PRODUCT BULLETIN # 20054

TITLE: Announcement of character missing on MPN Label

AFFECTED PERIOD: Products shipped from factory from Feb 5 to Mar 24

AFFECTED CHANGE CATEGORY(S): Shipping - MPN Label

Example:

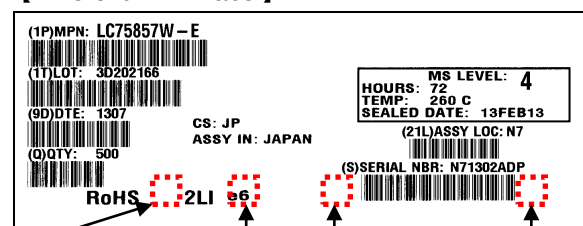
In this affected period, the following characters are missing due to the printing failure of MPN Label. There is no problem for other data at all.

1. Pb-Free
2. E-Category Value
3. China RoHS
4. ON Semi logo

This is the notification regarding about a labeling issue that occurred during the "AFFECTED PERIOD" stated above. After this period, the label became normal (like the "Good MPN Label" example).
